SSD 7348 MOD 8, OAKDALE WEST STAGE – S.4.55(1A) APPLICATION TO MODIFY ARCHITECTURE PLANS

As the consent authority for SSD 7348, the Department of Planning, Industry and Environment (DPIE) are authorised to modify the consent provided the above is met. This is the **Eighth (8)** modification to SSD7348 and seeks:

- minor amendment to approved architecture plans
- Appendix 2 update to reflect new plan references

Figure 1 – Approved office façade

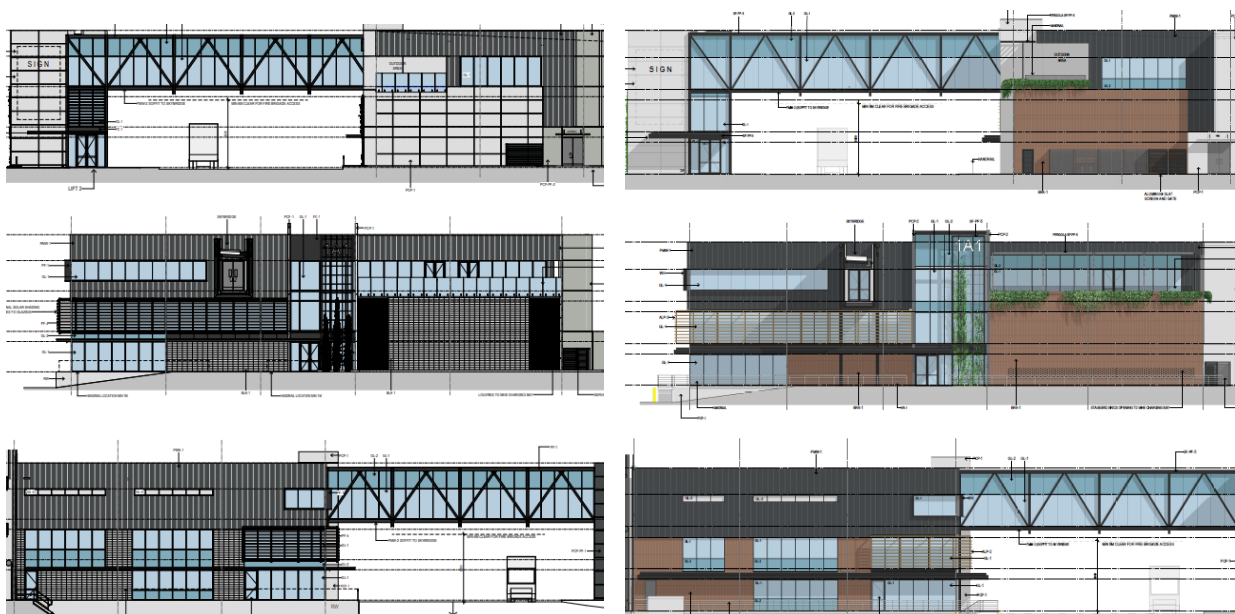
A) Warehouse 1A – Office façade update:

Since the 10 March 2021 MOD 6 approval, the design of Building 1A and 1B and 1C has been refined. Updates are proposed to enhance the façade treatment of the offices for Building 1A, 1B and 1C to a more modern aesthetic presentation aligned with new architectural trends. These updates will increase the appeal to new customers, and ensure the architectural presentation is more aligned to the future direction of the Goodman industrial brand. These façade updates will ensure consistency with the architecture language adopted by recent planning applications.

Figure 3 - Stair updates to warehouse 1A

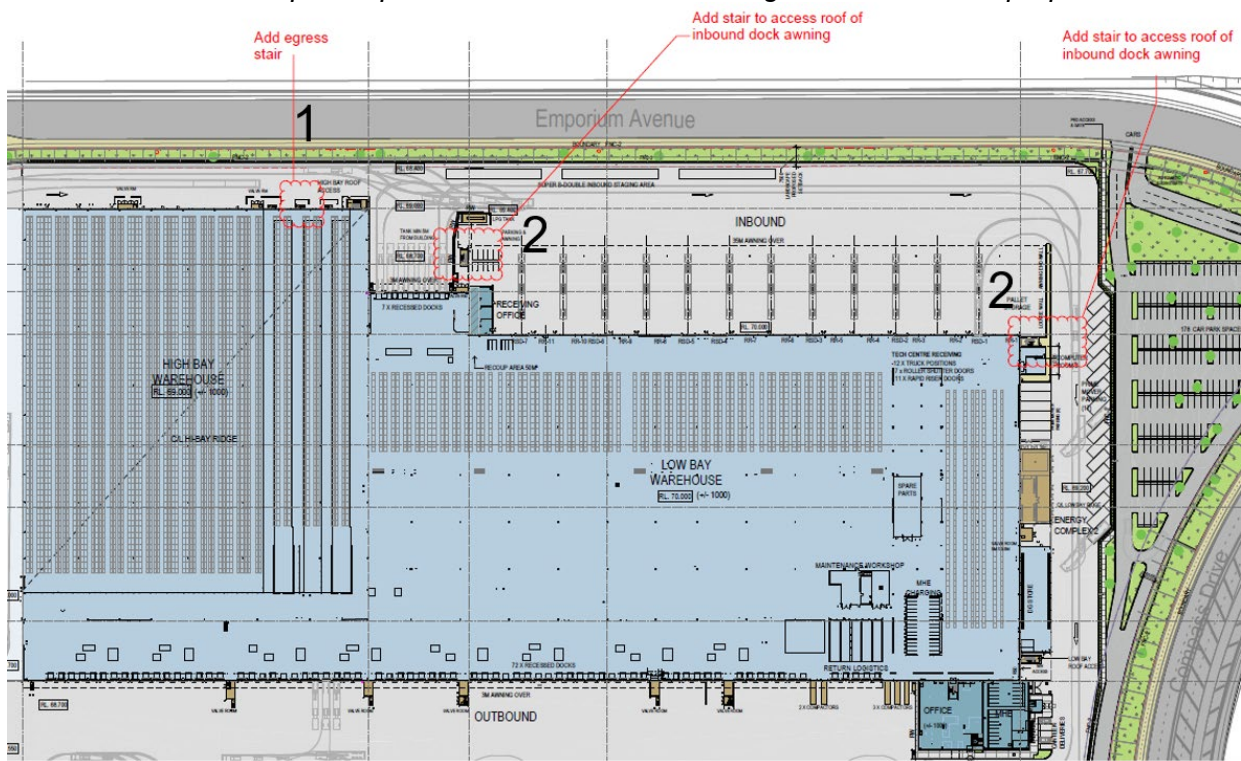
- 1) Egress stair added to the High Bay portion of the warehouse.

Reason for update: This is to allow for fire safety egress.

- 2) Access stairs added to enable access to roof of inbound dock awning

Reason for update: provide access to dock awning for maintenance purposes

Figure 8 - Approved Building 1C office facade

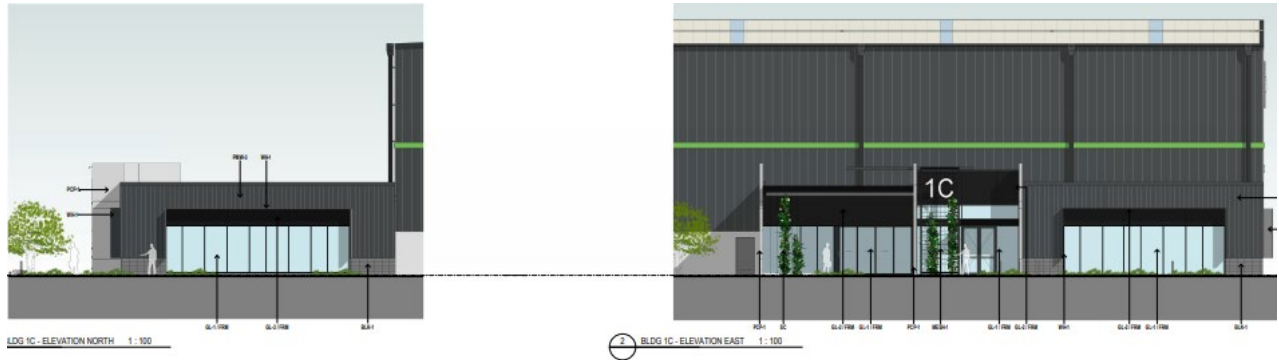
c) **Building 1C - Office façade update:** Office façade finishes updated to enhance presentation

Façade updates proposed to modernise and improve the aesthetics of the office facades.

Figure 11 - Proposed Updated Site Plan

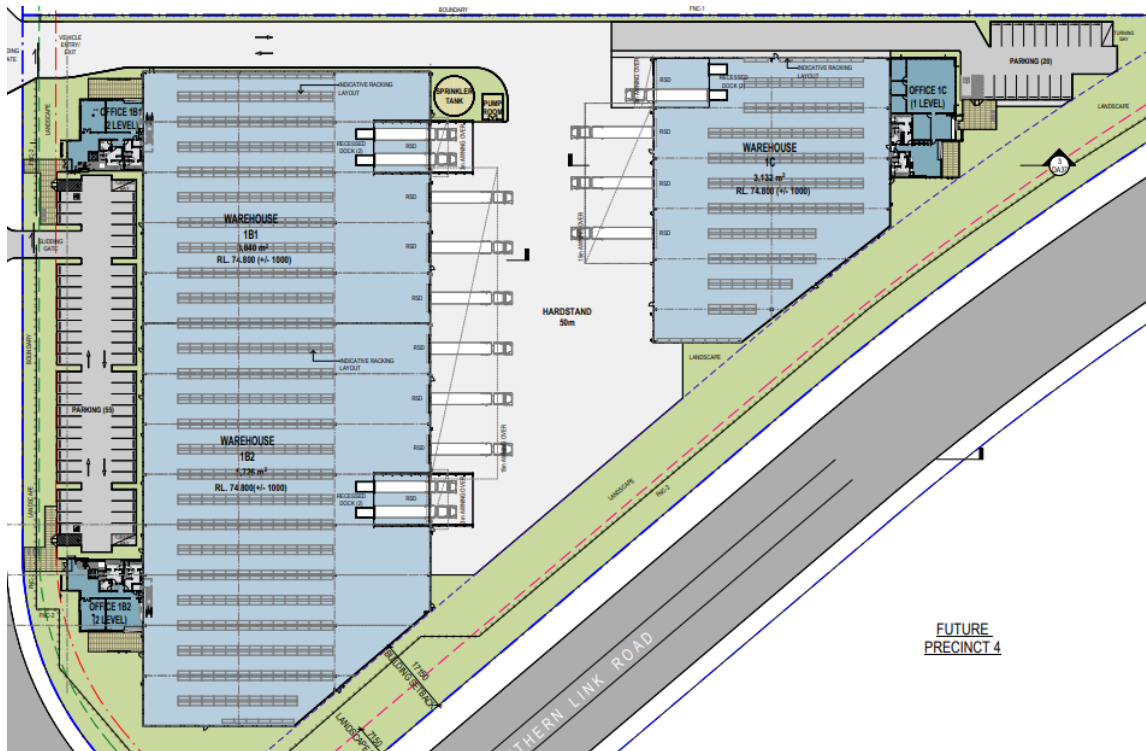
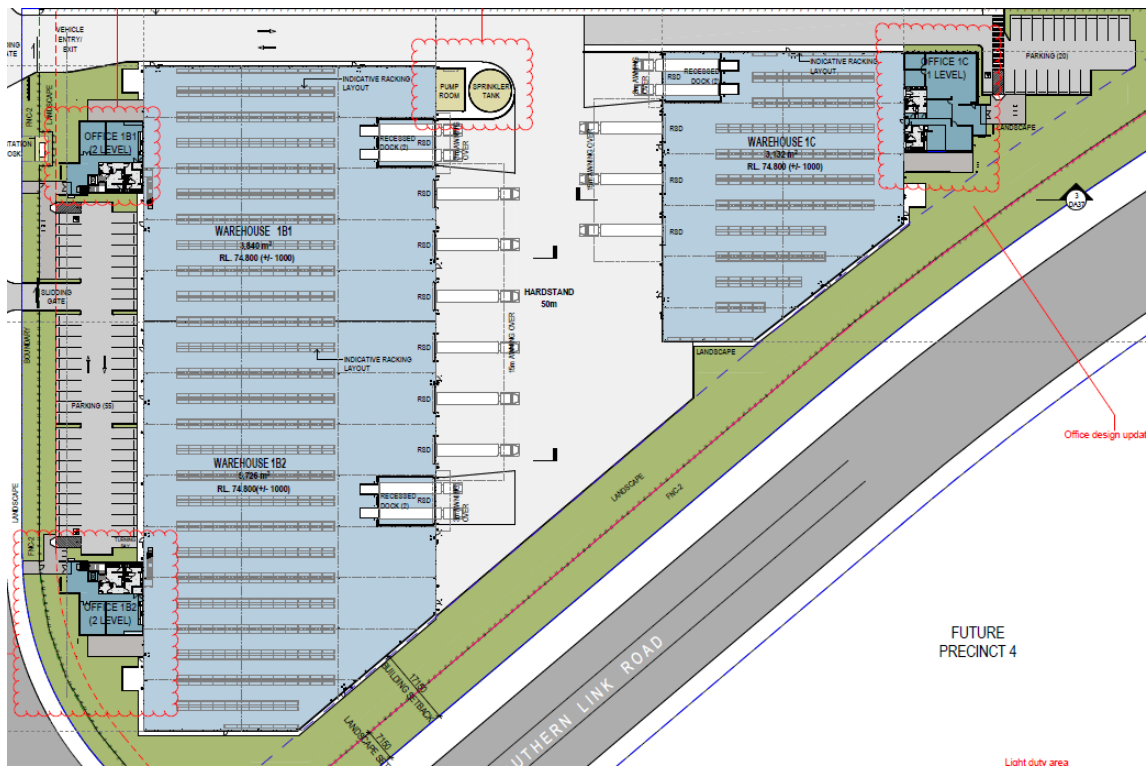
1) Office 1B-1 moved South and minor carpark layout update

*Reason for update: Office 1B-1 relocated slightly south to remove clash with required sub-station within the site frontage. This slight relocation also results in a minor reorganisation of car park layout. **No change to GFA or parking numbers result from this minor update.***

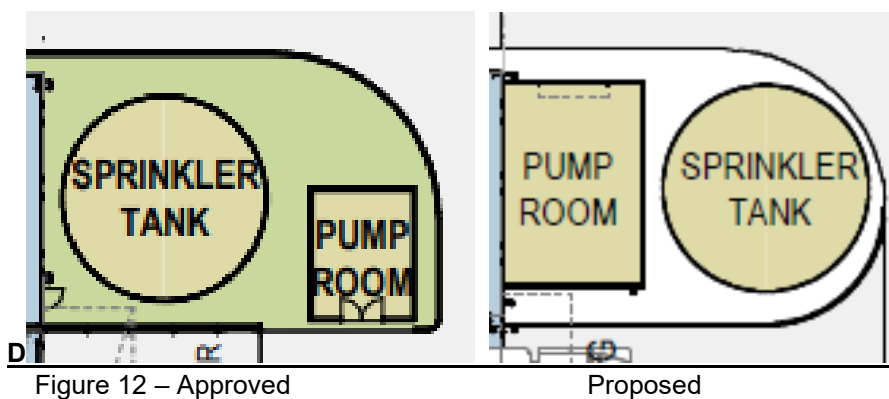
2) Sprinkler tank and pump room swap, located on the north east of Warehouse 1B-1, swapped.

Reason for update: The update to the sprinkler tank and pump room update will allow for rounded rather than square edge for enhanced swept path access for trucks into the adjacent Warehouse 1B1 loading dock.

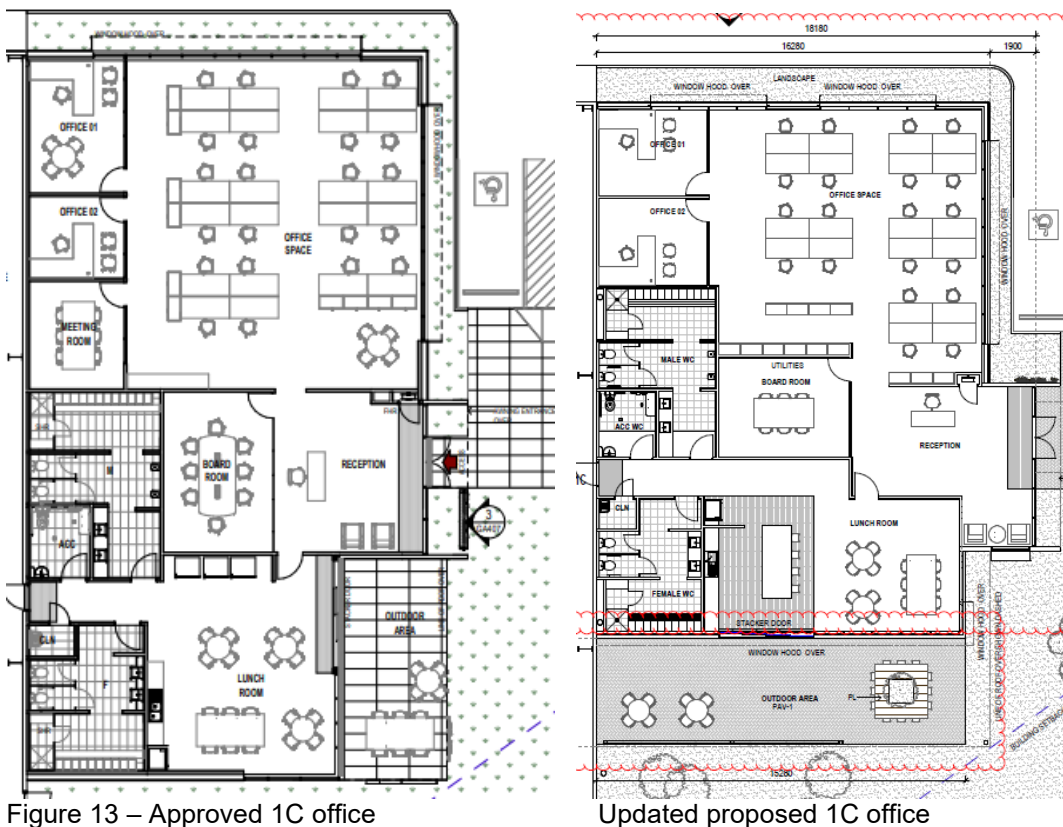
3) Warehouse 1C Office layout update and new outdoor amenity added

Reason for update: The office layout updated to enhance the operational layout and respond to new design intent. The update includes new outdoor space for improved staff amenity. GFA not increased due to updates.
